**FORMULA  
RENAULT 2.0**

## Technical Bulletin N°1

**Reference:** BT\_2008\_FR20\_01  
**Date:** January 22<sup>th</sup> 2008  
**Subject:** 2008 Evolutions

Front wing:

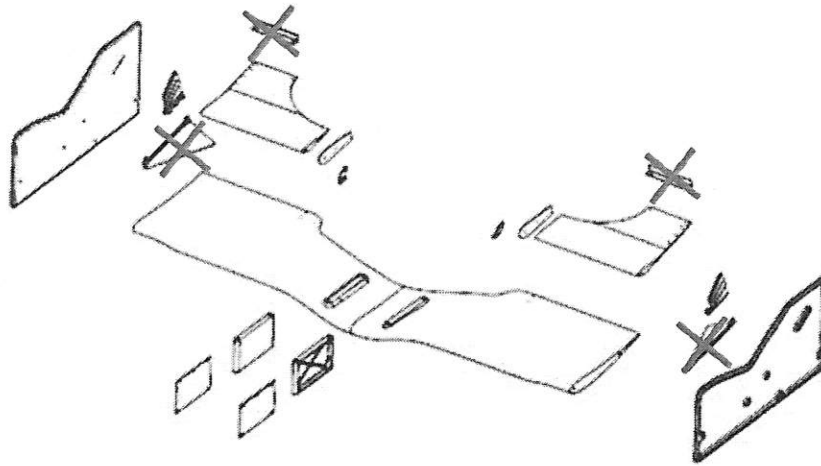
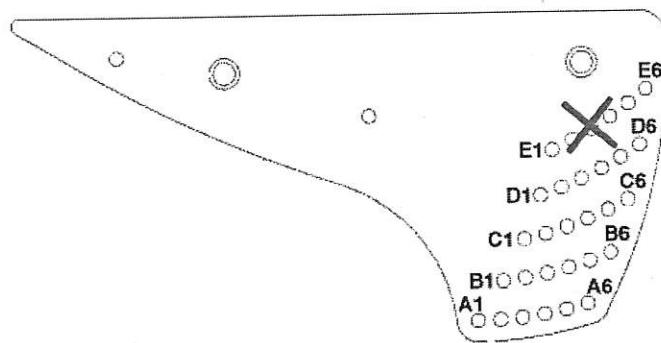
Rear diffuser:

- 77 11 163 100 Central diffuser fences
- 77 11 163 101 Left diffuser fence
- 77 11 163 102 Right diffuser fence

- 77 11 163 079 Left flick-up
- 77 11 163 080 Right flick-up
- 77 11 163 088 Gurneys

In addition, the use of the highest line of the rear flap regulations holes (From E1 to E6), will be prohibited. Note: new parts will progressively be sold without this line.

From the first 2008 collective test, all the following parts must be removed from the cars to be in conformity with the 2008 technical regulation.

It is allowed to fix the holes.

New part

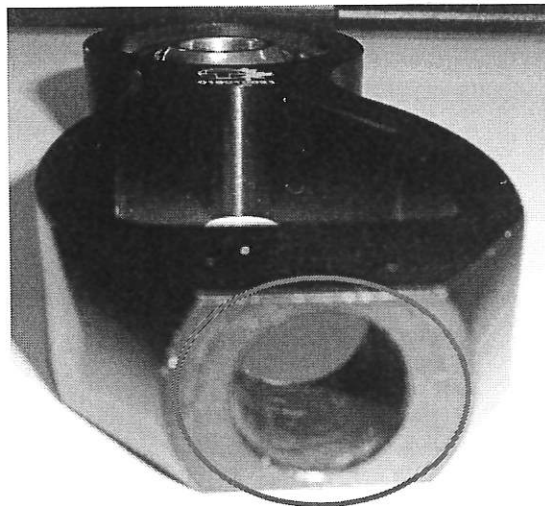
New rear toe-in supports (reference of the genuine part: 77 11 154 539) are now available at the Renault Sport Spare Parts Department from this week end. The thickness of the part is increased by 4 mm around the through hole following to a few cases of cracking at this site.

These new parts are specified under the reference 77 11 163 148.

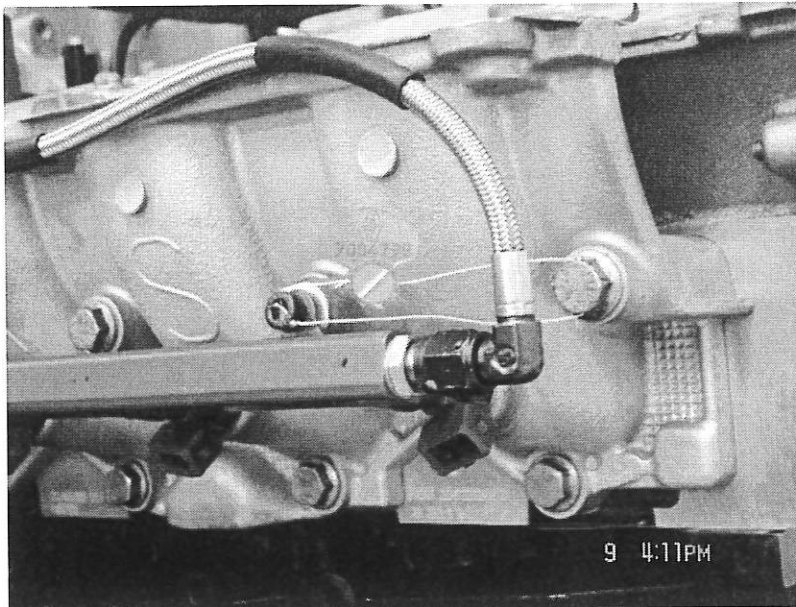
From now on, for an engine dyno test or/and an engine rebuilding at our engine tuner Oreca Magny Cours, engines will have to be delivered with their fuel rail and injectors.

The fuel rail will be sealed for the 2009 season as shown on the picture below :

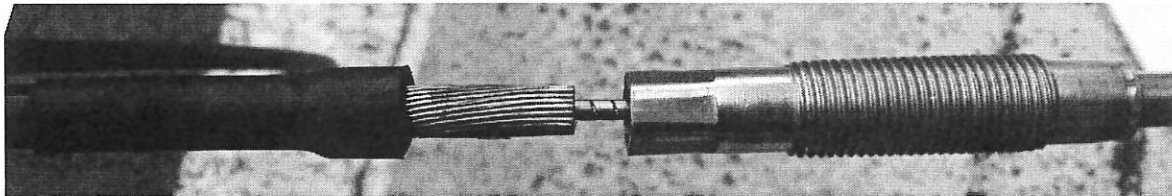
A production problem in 2 batches of push pull cable (Ref 77 11 154 263) has been detected. This concerns cables with the reference "08/09" or "09/09" written in white on the cable casing.

A crimping problem might appear after a few kilometres on some cables with these references, as shown below:

If you have such cables, check with your local Renault Sport spare parts dealer to arrange the exchange.

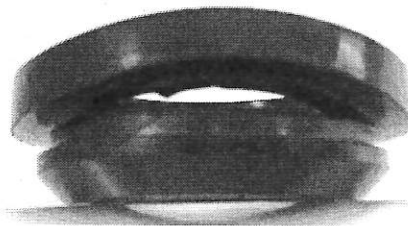
- It is allowed to reduce the radius coming from the machining process of the original part, (1) as shown on the picture below :

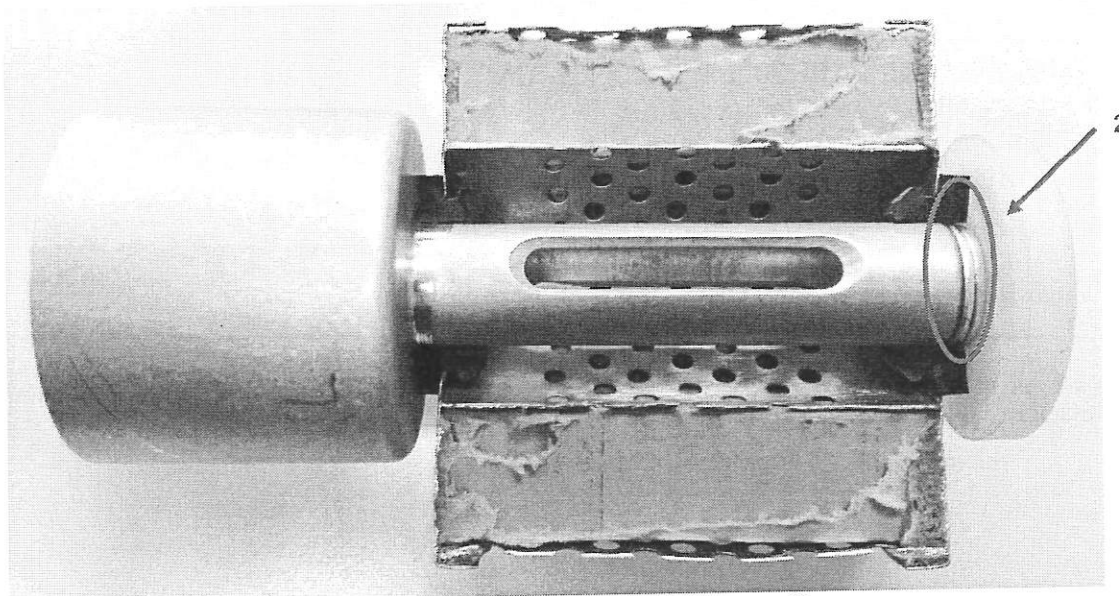
**NOTA:** this modification ensures a lifetime increased for the seal, and avoids any cut as shown below:

Sectional view of the filter assembly

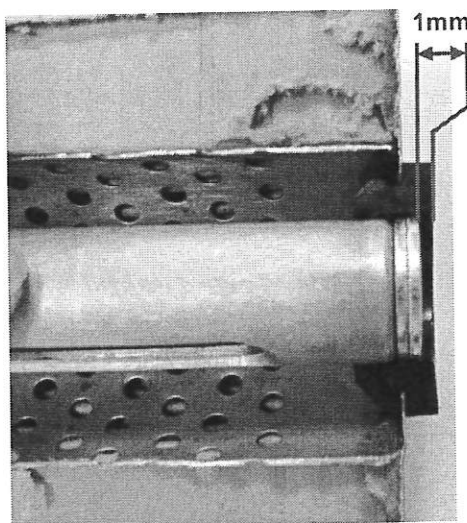
- It is allowed to add shim(s) (2) between the filter support and the PTFE washer retaining the filter, in order to avoid any damage of the filter and its seals during a too much important tightening :

- It is recommended to let an approximate gap of 1mm before fastening, between the PTFE washer and the shim(s):

- The use of STANDARD locking compound (Loctite® 243 type) is strongly recommended.

Holes not clogged

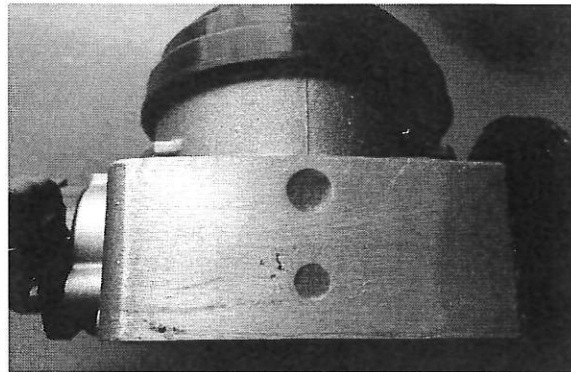
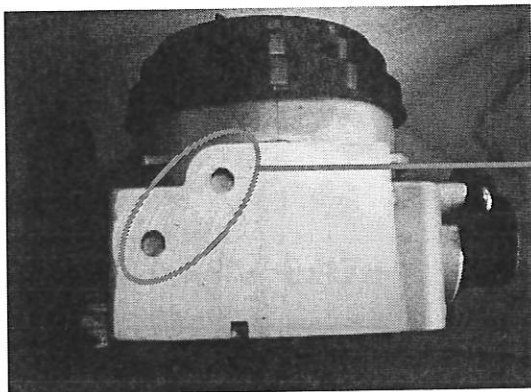
A default has been found on a batch of throttle bodies of the Renault Sport Spare Parts Department: the 2 holes of the under machined surface aren't filled. It is mandatory to fill them with a glue type **Loctite 3455 Hysol**<sup>®</sup> (Aluminium Epoxy). This fast-drying glue is available at the Renault Sport Technical Support, if needed.

**NOTA:** Renault Sport advises you to fill the holes completely and to not forget to clog the holes (air intake pipe side) to prevent from any leakage.

Genuine machined body

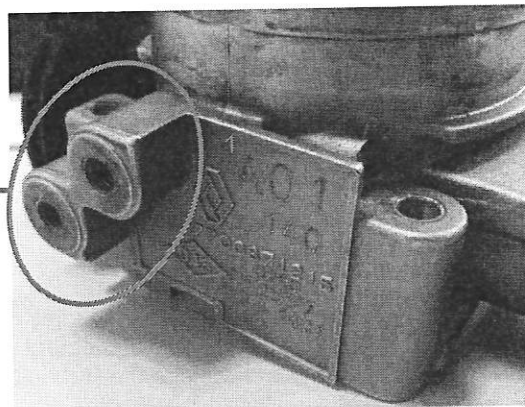
Otherwise, the superior surface of a few genuine throttle bodies is machined. The 2 raw bosses (1) are so deleted. The 2 types of throttle bodies are allowed.

### 2 Upper front barge board support

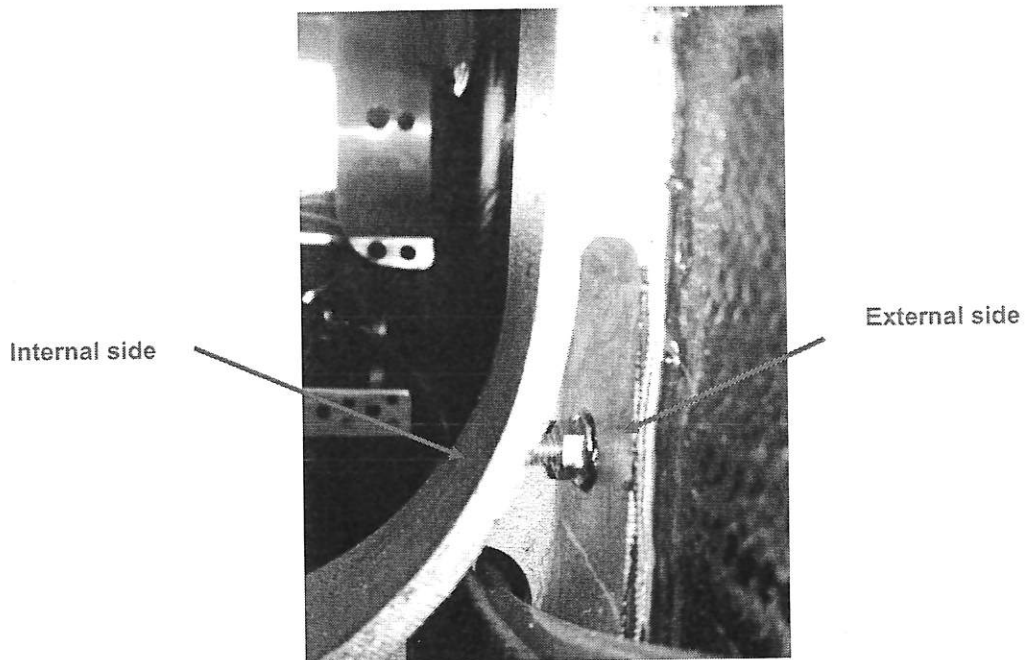
In order to make easier any upper front barge board support repair, it is allowed to fit it with a M5 stud ( 8.8 minimum class quality required ) right through the tub, fitted as shown on the picture below :

It is mandatory to respect a maximum diameter of 5 mm to drill the tub.  
It is only permitted to drill the external side of the aluminium frame.

### 2. « push pull » cable fitting

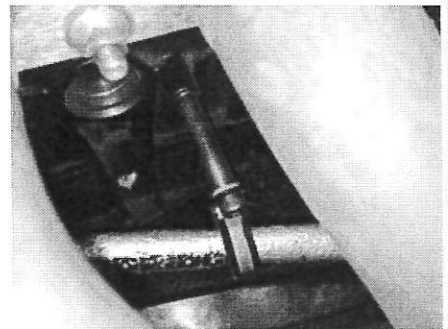
It is allowed to add a shim to your "push pull" cable support, in order to keep the cable clear away from the engine block. Only one type of mounting is still allowed by the Nomenclature.

### 1. Radio and dashboard control buttons

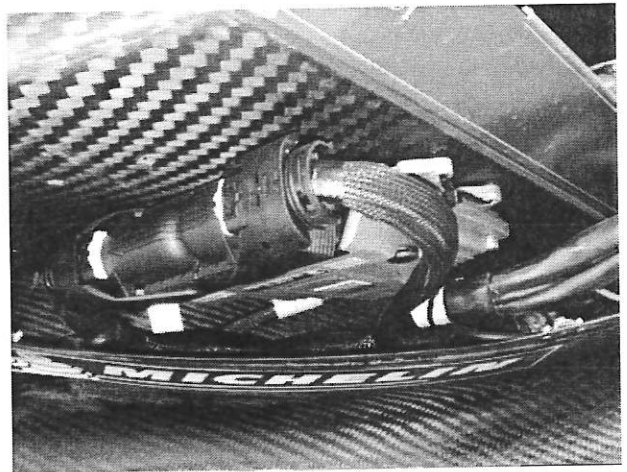
It's forbidden to weld a new controls-bracket (part n°77 11 154 520) on the quick release hub.

To fit extra buttons, it is allowed to fit a metallic or composite plate on the steering wheel assembled by the 3 central screws (circled in red) maintaining the wheel to the quick release hub.

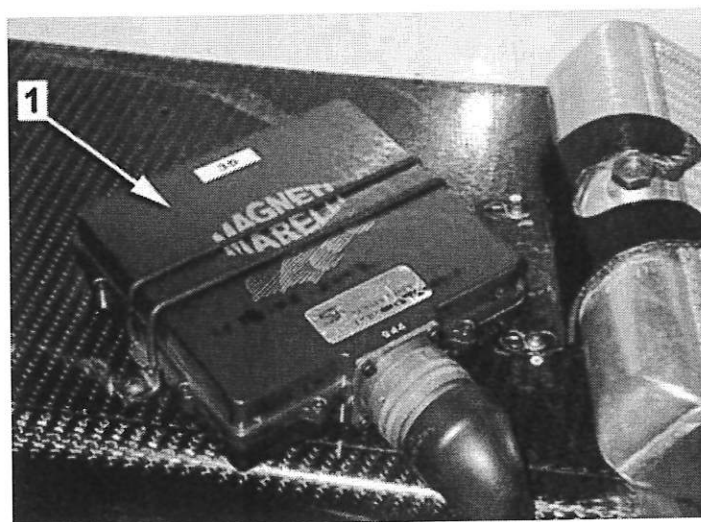
- **SRAE fitting:** it is allowed to drill the left radiator duct on this purpose. (Using plastic collars)

The E.C.U. is located on the side of the left radiator duct.

### 3. SRAE sealing

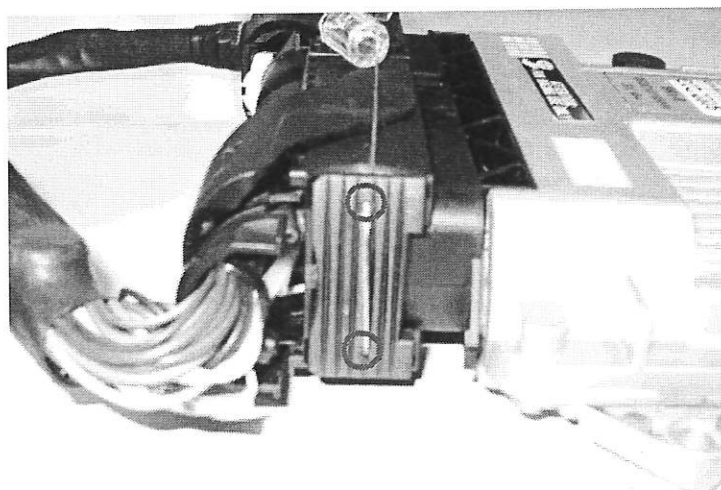
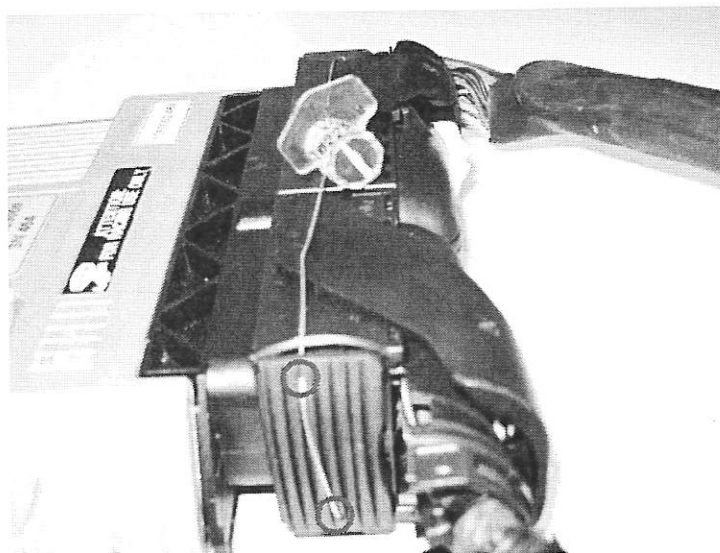
SRAE will be sealed on the first meeting. To prepare the sealing, teams which own SRAE must make 4 holes according to the pictures below (circled in red):

As a consequence, SRAE will be unplugged using exclusively the round souriau military connector, for reliability purposes.

#### 4. New oil pump stainer regulation

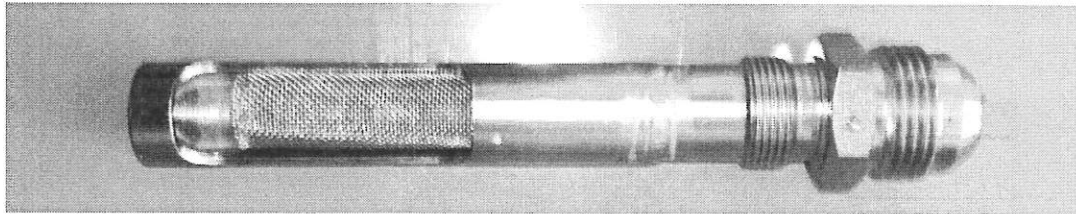
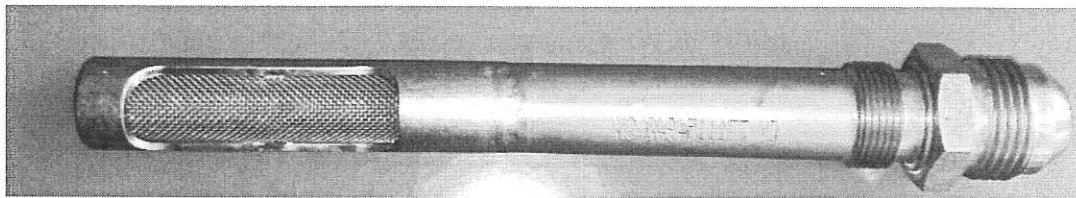
For the first meeting of each championship, it will be mandatory to use the long oil pump stainer reference **77 11 154 940**. This part has been introduced early 2006 on all new cars. The price of this part is 82,2 € VAT excluded.

To recognise what type of oil pump stainer you have, just look the reference number engraved on the part.

Central wooden floor

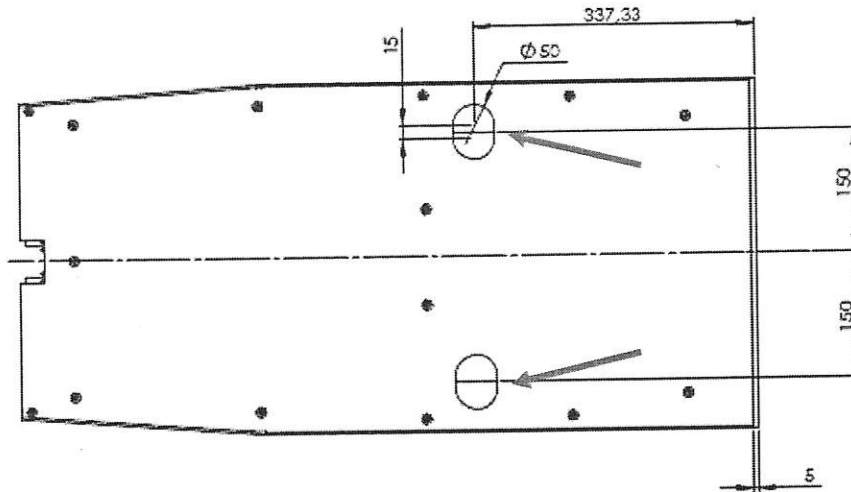
For all Formula Renault 2.0 2008 championships, the central wooden floor (ref 77 11 163 104) must be drilled in order to enable the Renault Sport scrutineers to check all the cars on the Renault Sport control plane. Two holes must be drilled according to the drawing below:

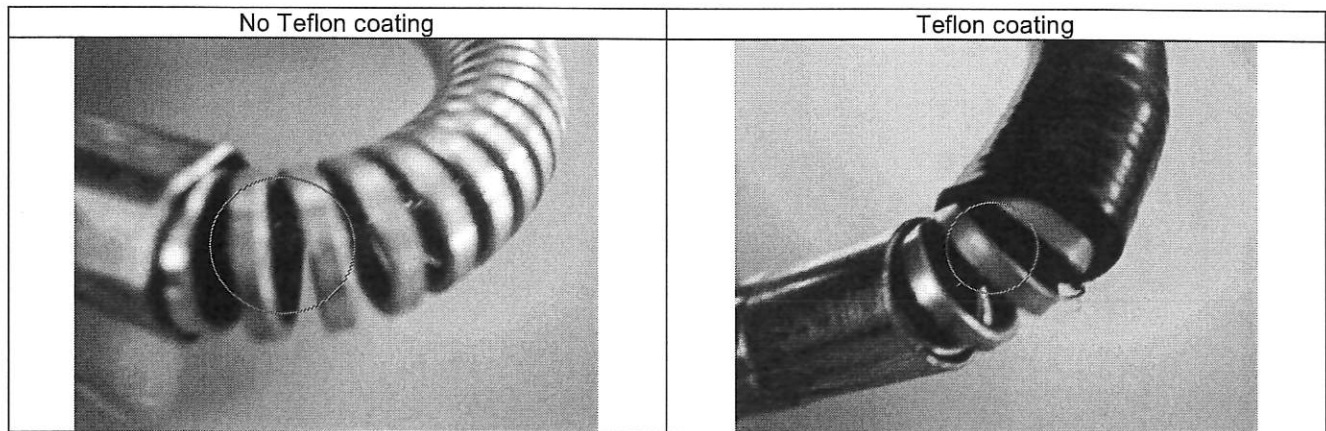
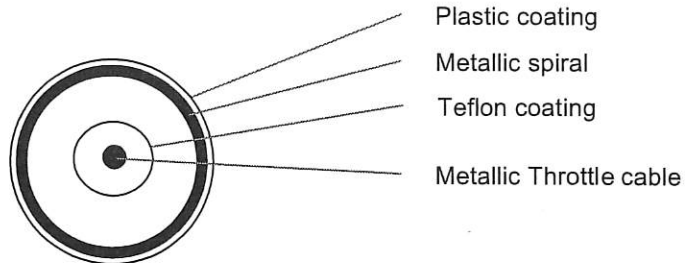
The lack of Teflon coating around the cable can create problems (harder pedal).

Please check that the cable mounted in the car has a Teflon coating (see picture underneath).

If you have such cables, check with your local Renault Sport spare parts dealer to arrange the exchange. A new production batch is being processed and should arrive shortly.

*Central wooden floor*

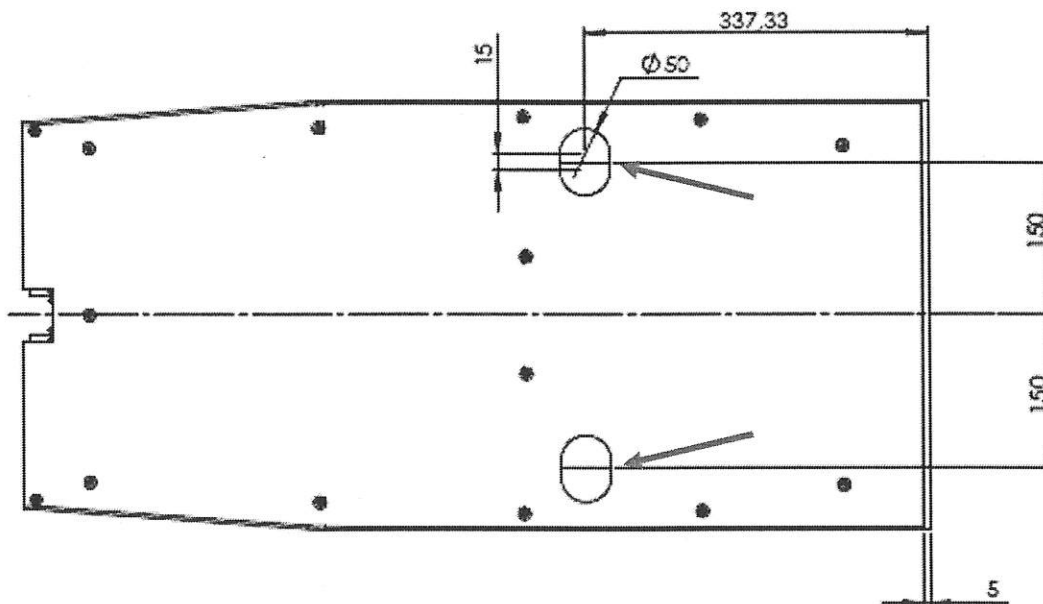
For Formula Renault 2.0 Eurocup 2008, the central wooden floor (ref 77 11 163 104) must be drilled in order to enable the Renault Sport scrutineers to check all the cars on the Renault Sport control plane. Two holes must be drilled according to the drawing below:
